UNITED STATES DEPARTMENT OF COMMERCE United States Patent and Trademark Office Address: COMMISSIONER FOR PATENTS P.O. Box 1450 Alexandria, Virginia 22313-1450 www.uspto.gov

| APPLICATION NO. | FILING DATE | FIRST NAMED INVENTOR | ATTORNEY DOCKET NO. | CONFIRMATION NO. |
|----------------------|---|----------------------|---------------------|------------------|
| 10/552,145 | 09/14/2006 | Hiroyuki Takahashi | 279408US3PCT | 7135 |

| | | Application No. | Applicant(s) | | | |
|---|---|--|--|--|--|--|
| Office Action Summary | | 10/552,145 | TAKAHASHI, HIROYUKI | | | |

DETAILED ACTION

This figure, now referred to as annotated Fig. 7, used for the rejection of claim 13 has been replicated below, and the Examiner has added reference points for ease of explanation, and said reference points will be used for the rejection of claim 13 below.

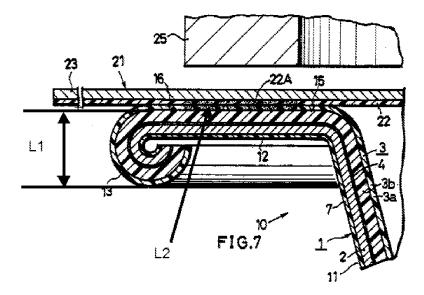
As to claim 13, Tamura teaches the container according to claim 12, wherein an extending dimension (L1, annotated Fig. 7) of the end of the innermost layer of the flange is no less than 1.2 times as large as a distance (L2,

annotated Fig. 7) between an upper surface of the innermost layer and a peeled surface (joint layer 5) of the flange (Fig. 9), the peeled surface being formed by layer peeling generated between the innermost layer and the adjacent layer (col. 8, lines 10-11).
